**ASBESTOS-CONTAMINATED SOIL MANAGEMENT
STANDARD OPERATING PROCEDURE
For City and County of Denver**

December 3, 2010

Department of Environmental Health, Environmental Quality
Responses to June 16, 2010 CDPHE comments on City and County of Denver
Asbestos-Contaminated Soil Management Standard Operating Procedure (SOP)
July 23, 2010 – Revised November 19, 2010

Figure 1. Site Review and ACS Potential Classification Flowchart

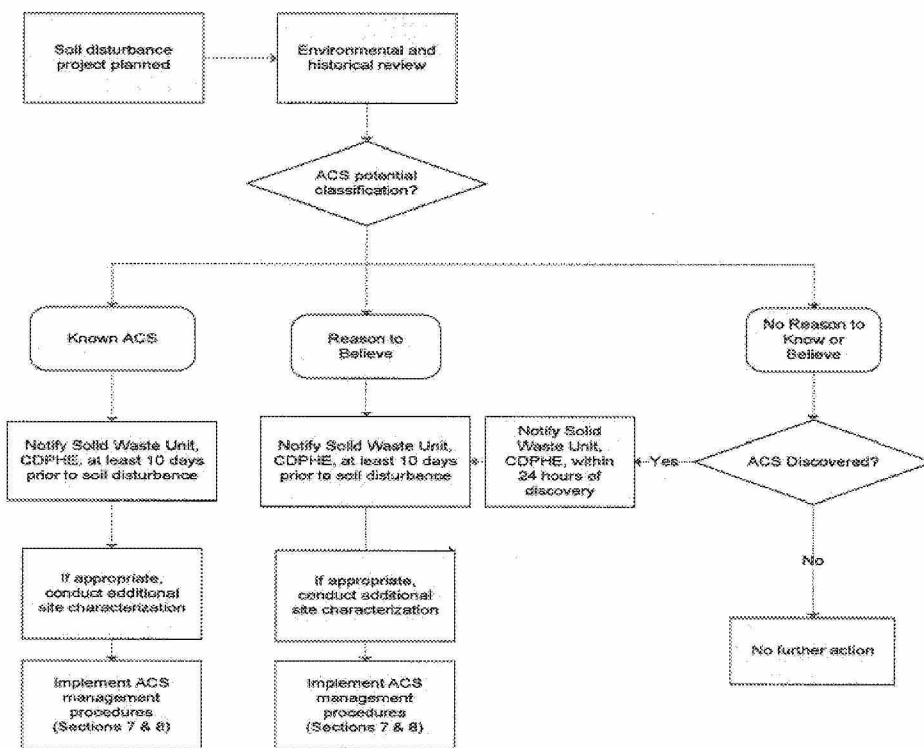
Comment 7: Page 4, Figure 1, last box under Low Potential, change Section “4” to Section “6”.

Comment 8: Page 4, Figure 1, last box under High Potential, delete current language and state that “An ABI will be present during soil-disturbing activities.”

Comment 9: Page 4, Figure 1, under High Potential, add last box that contains language “If ACM is observed, implement ACS management procedures of Section 7 and Section 8.”

Comment 10: Page 4, Figure 1, the boxes under “Elevated Potential” should reflect same approach and language as boxes under “High Potential” because you’ve already established a “reason to believe” that asbestos may be encountered on these sites.

Response: Figure 1 was revised to reflect changes in the text as noted in response to Comment 4.

Response: Figure 1 has been revised to reflect the response to Comment 4.

Response: Please see response to Comment 8.

Response: Please see response to Comment 8.

Figure 2. Unanticipated discovery of asbestos in soil flowchart

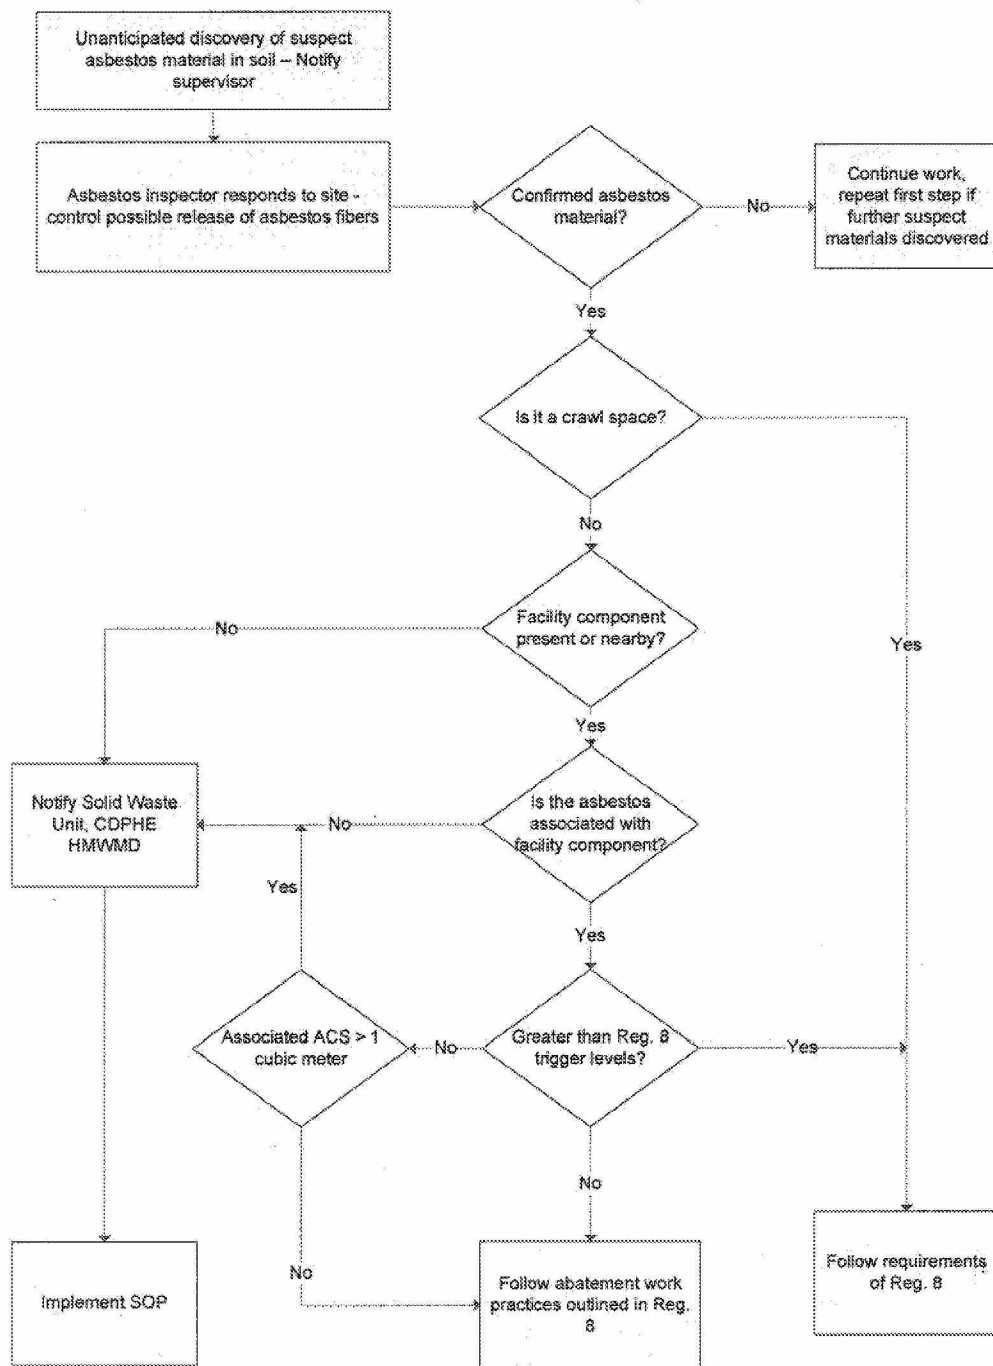
Comment 26: Page 13, Figure 2, make separate boxes for the current “facility component” diamond to outline options for above trigger level and below trigger level scenarios. You may refer to the flow chart in the current CDPHE guidance document.

Response: The requested change has been made.
